Vermont Agency of Transportation
RECEIVED
FRL-COLCHESTER - comments.pdf

RESUBMIT YES Rejected

BRIDGE RAIL DETAILS SHEET

T.H. 27 (URBAN COLLECTOR), BRIDGE # 12
TOWN OF COLCHESTER, CHITTENDEN COUNTY

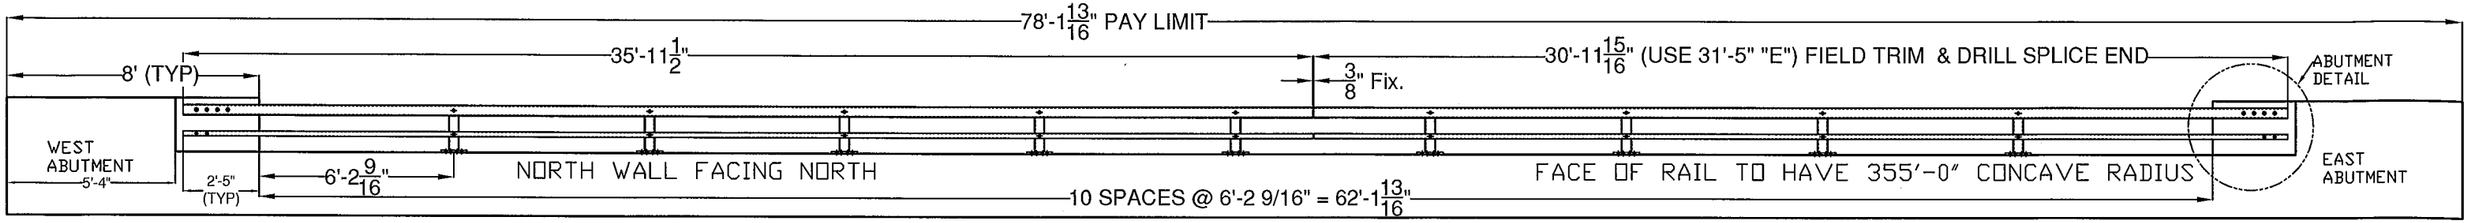
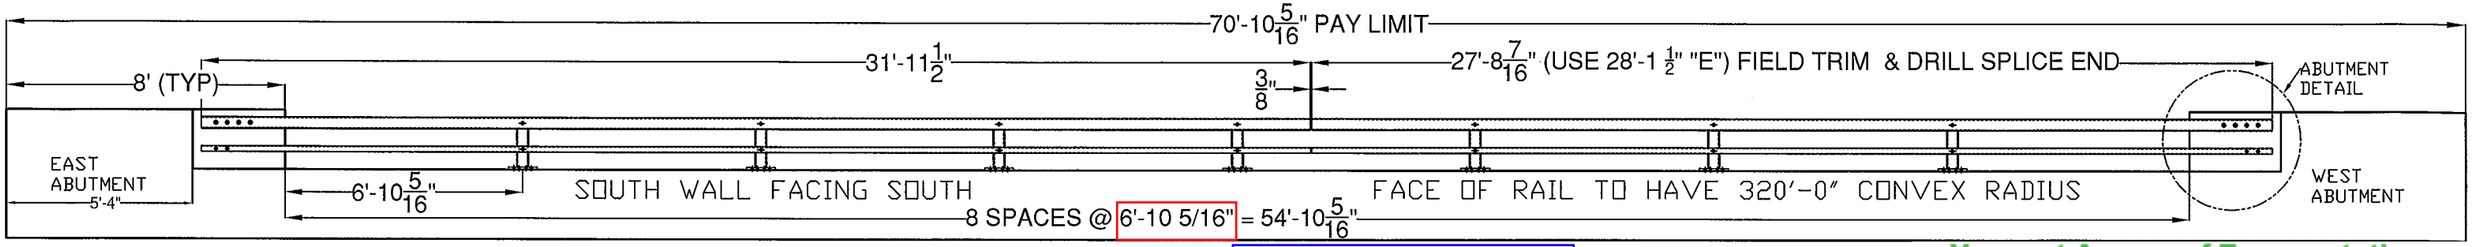
Max Spacing 6' - 8"

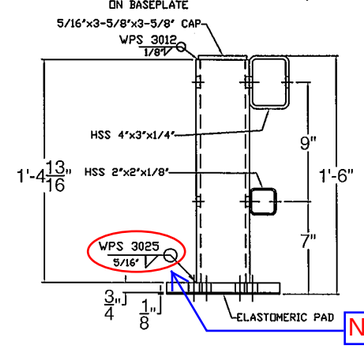
Need WPS 3025

SHEET 2 OF 6

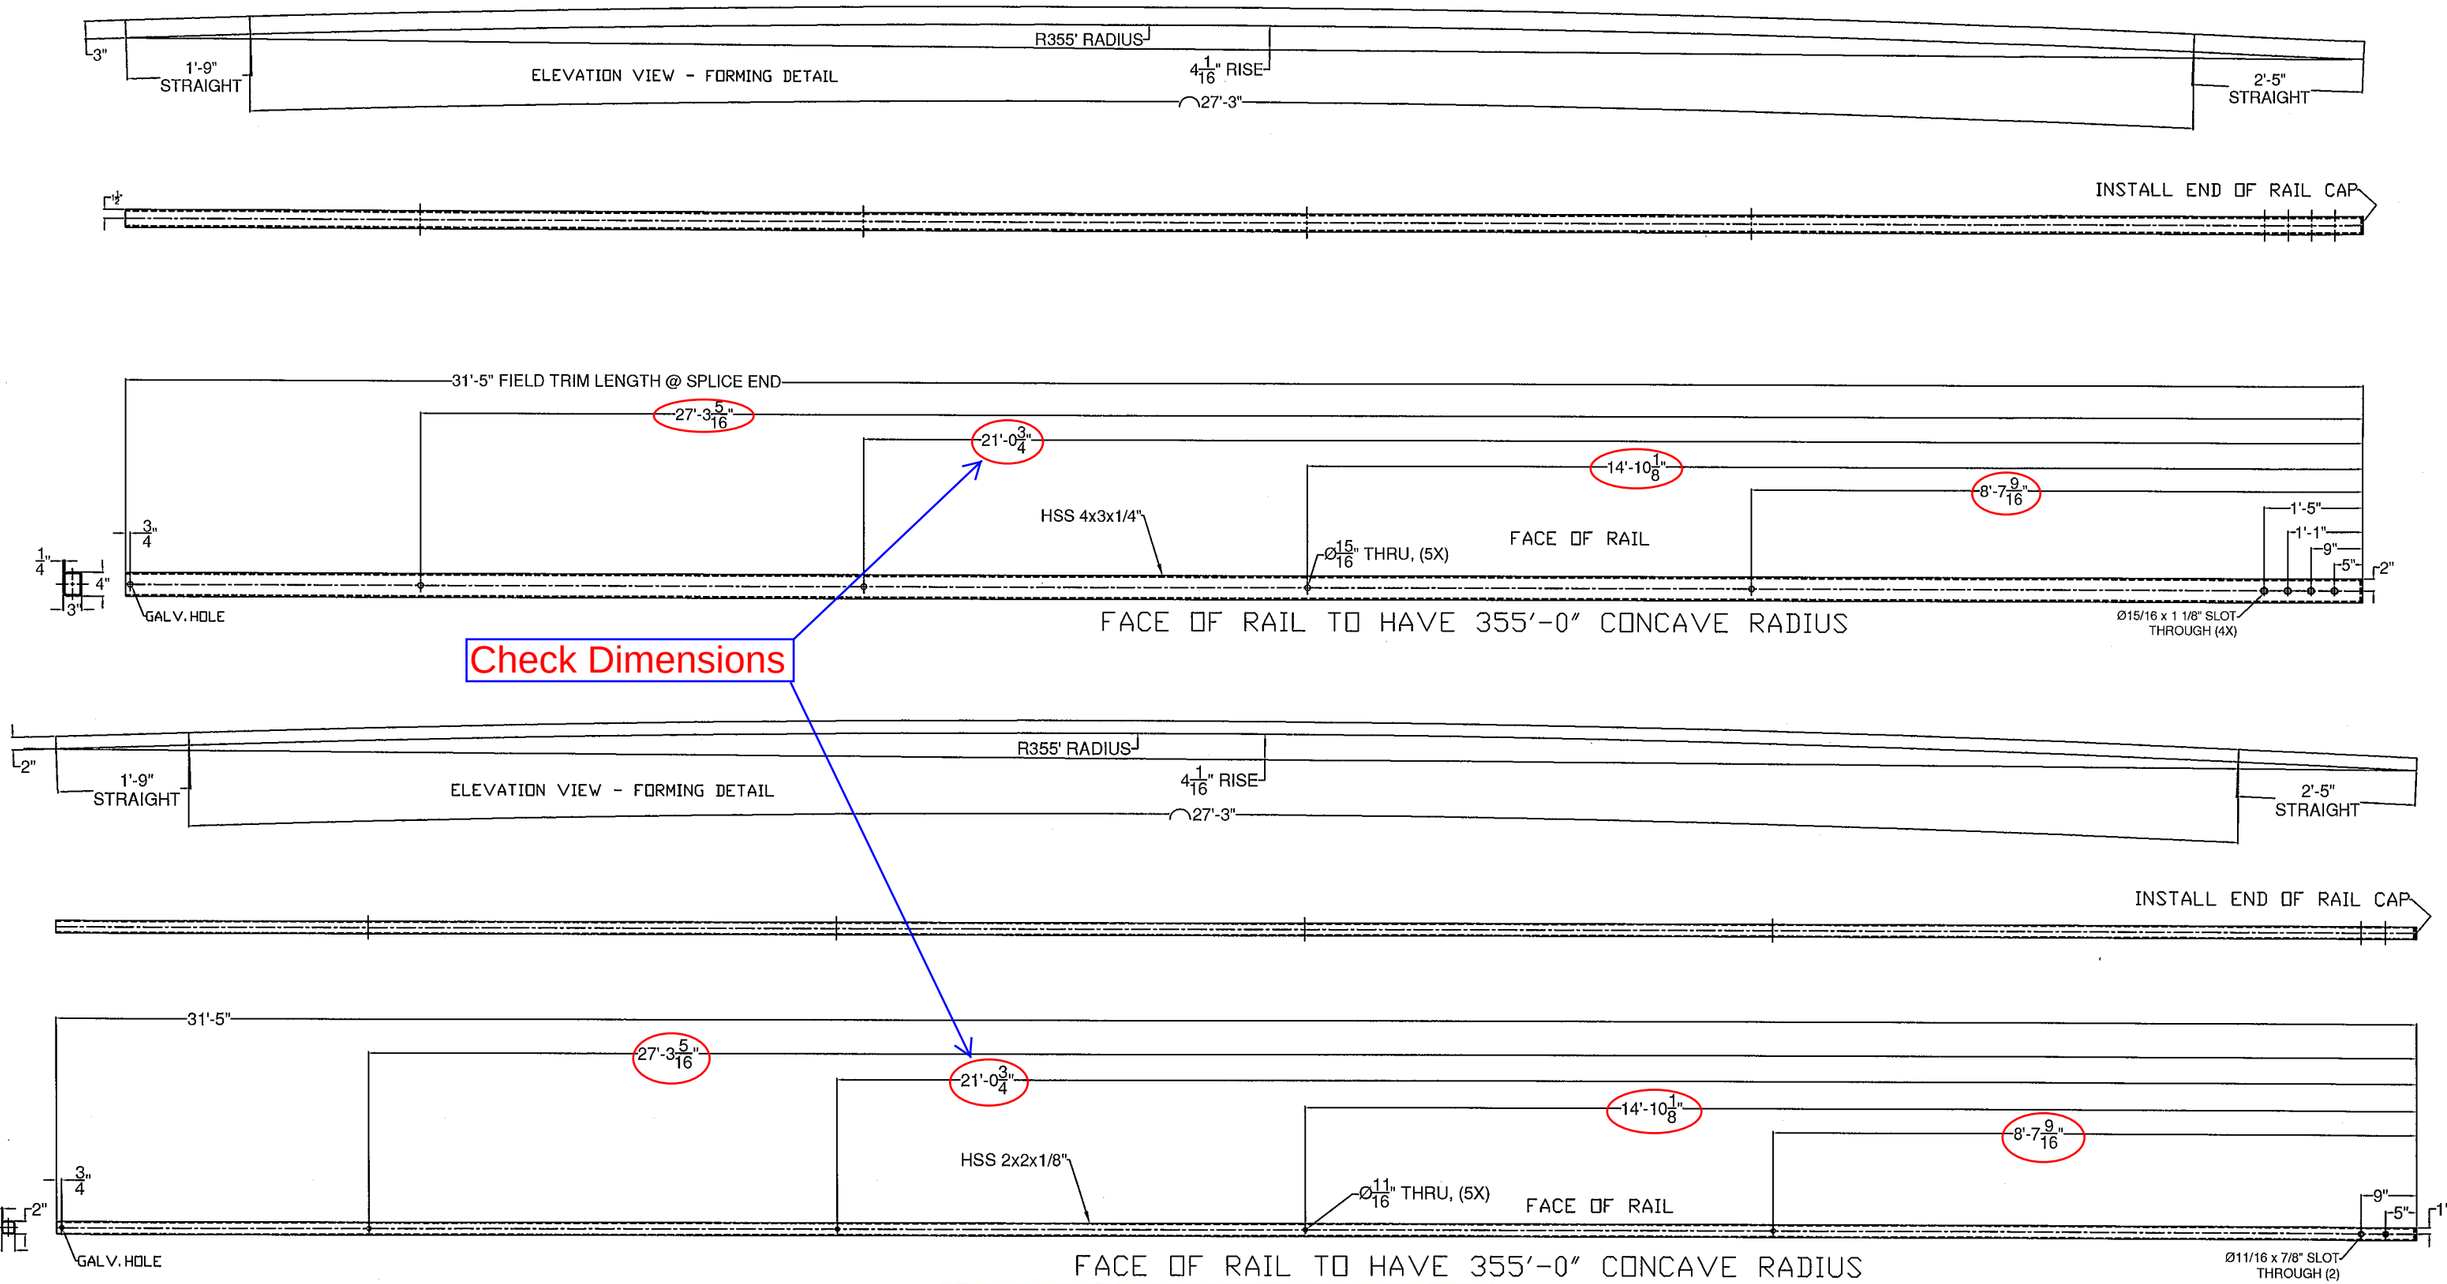
Check Dimensions

SHEET 3 OF 6

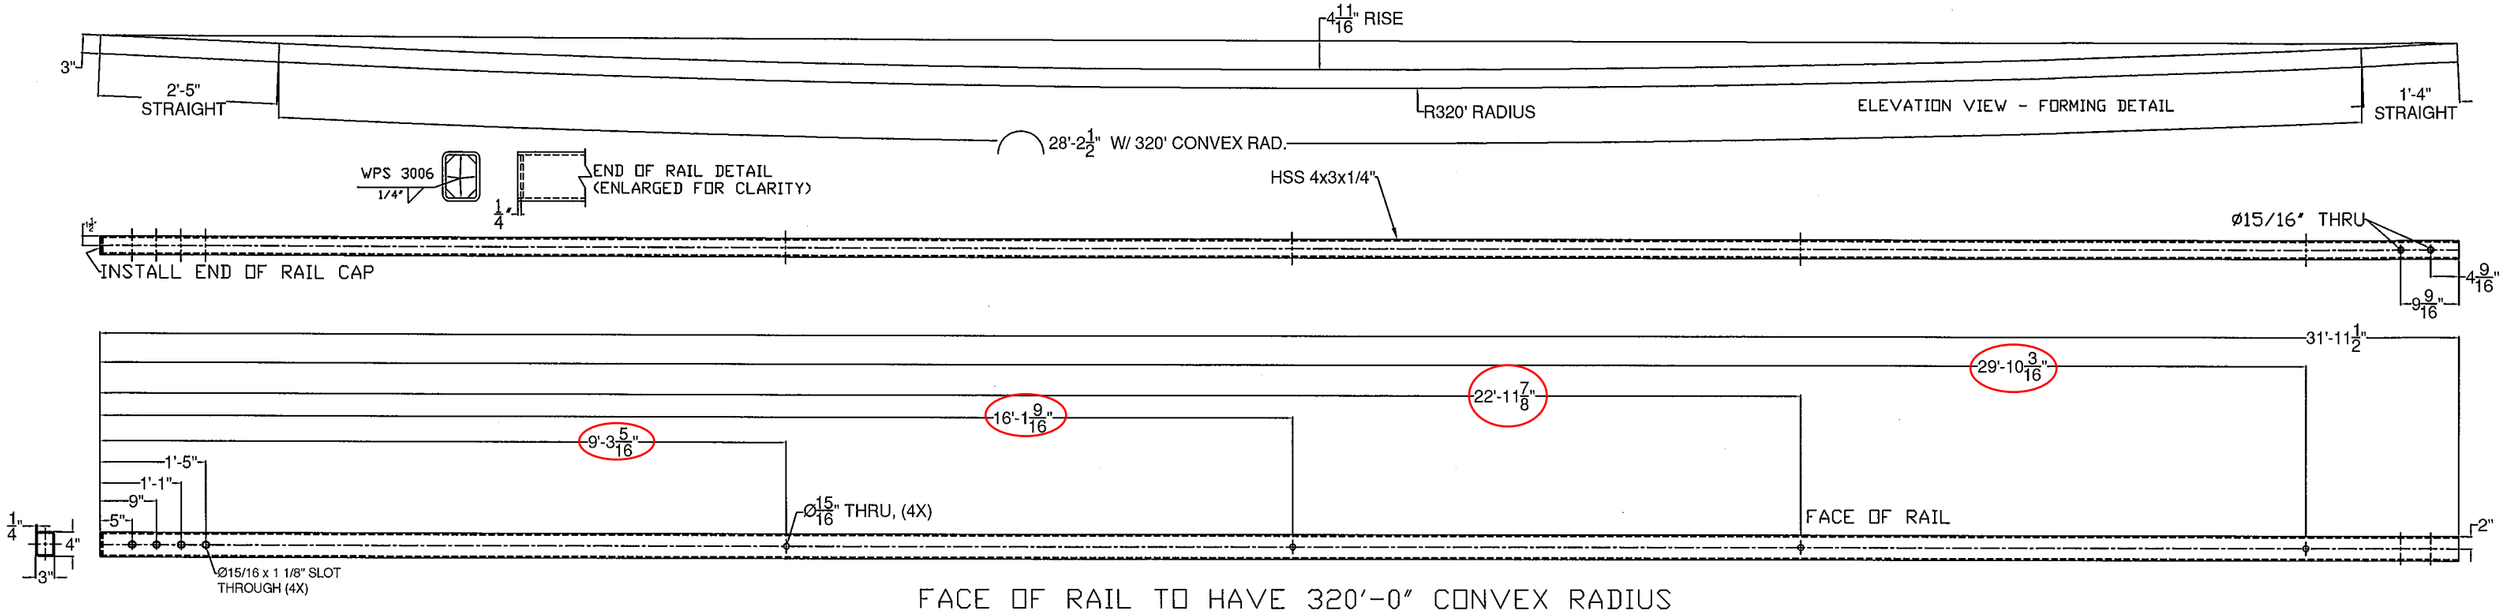
Spacing is greater than 6' - 8"

SHEET 4 OF 6

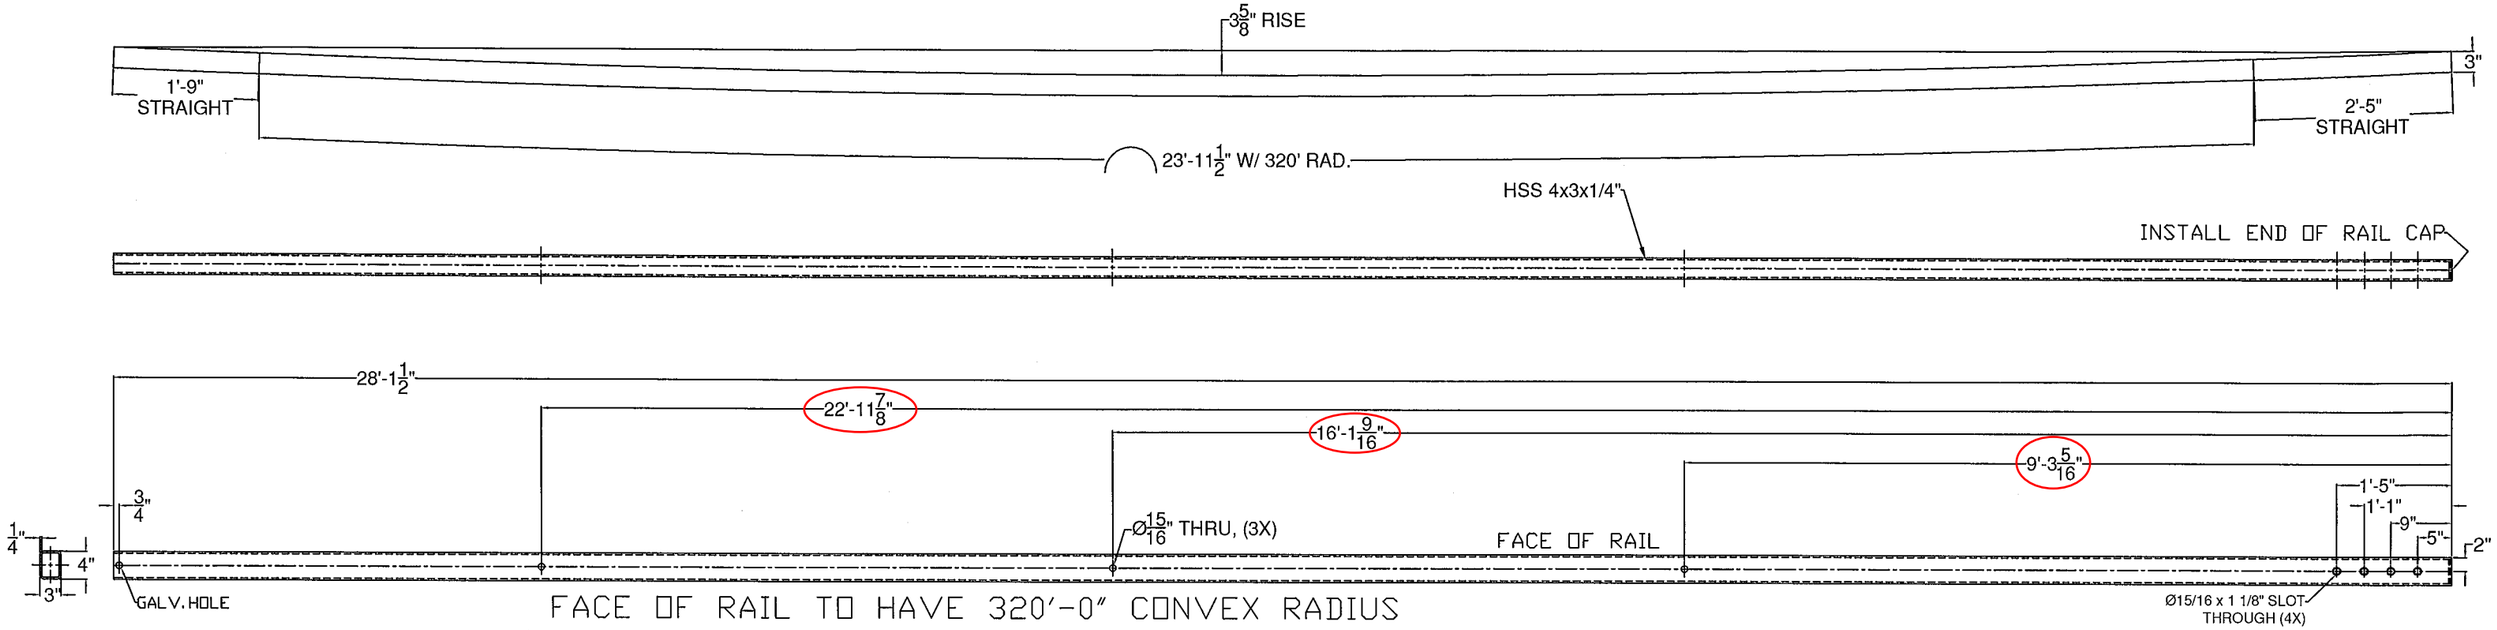
Spacing greater than 6' - 8", check dimensions
